Architectural Review
and Historic Preservation Board
Agenda Report

File: AR 17-32

RE: Grove Office Building, 1270 E. 9th Street; APN 004-331-036
New shell building

STANDARD 'SHOEBOX' STYLE (GARDCO: ECOLUME MODEL: EC A 14 1 3V 150HPS 120 BRP WITH CUTOFF SHROUDS TO ELIMINATE LIGHT SPILLAGE ONTO ADJACENT PROPERTY AND INTO NIGHT SKY).
TYPE OF LAMP: 150 WATT HIGH PRESSURE SODIUM.

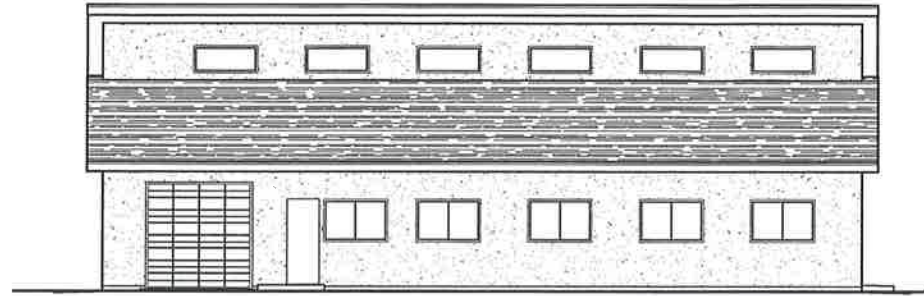
The design, material selection and color pallet of the proposed office structure are visually compatible with the surrounding residential and commercial office structures. Conditions of approval will ensure architectural design elements are included on all elevations of the structure and parking lot light standards are limited to 12 feet above grade. Exterior equipment will be properly screened by fences, landscaping or painted to match the structures.

2. All new exterior lighting shall be full cutoff and directed onsite such that no light shines offsite and luminaires are minimally visible from adjacent properties. Parking lot light fixtures shall not exceed a total height measured from grade of 12 feet.

NORTH-EAST ELEVATION

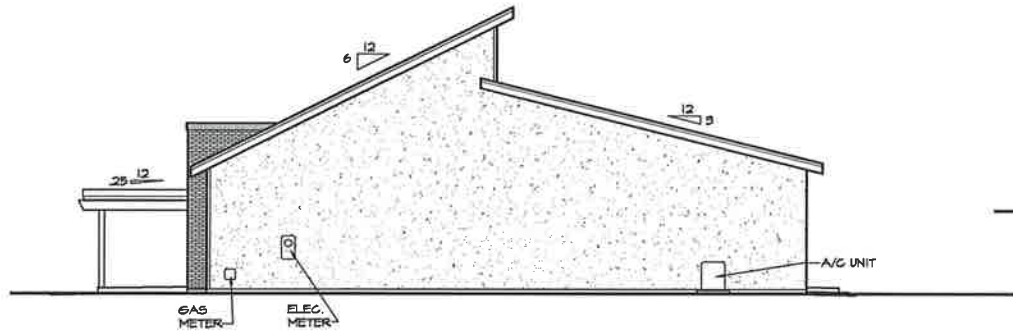
The design is challenged by several DGs that encourage a pedestrian orientation by locating buildings closer to adjacent streets and parking in less visible locations (DGs 1.1.13, 1.1.14, 1.1.15 and 3.1.25). The building presents a dominant front entry element; however, the design encourages visitors to walk through the parking area to enter the building, resulting in partial consistency with DG 3.1.11. The absence of architectural elements on three sides of the building is inconsistent with DG 3.2.33 which encourages design continuity throughout all elevations. To better achieve consistency with design guidelines, a condition of approval is recommended to add architectural design elements to the northeast and southwest elevations.

Given that the required finding #3 compels the architectural design to be carried around to all four elevations, discuss the need for additional architectural design elements on the northeast and southwest elevations of the building, such as penetrations or additional landscape features. Modify condition of approval #4 as necessary.

4. The applicant shall provide architectural design elements to the northeast and southwest elevation.
5. All wall-mounted utilities and roof or wall penetrations, including vent stacks, utility boxes, exhaust vents, gas meters and similar equipment, shall be screened by appropriate materials and colors. Adequate screening shall be verified by planning staff prior to issuance of a certificate of occupancy.
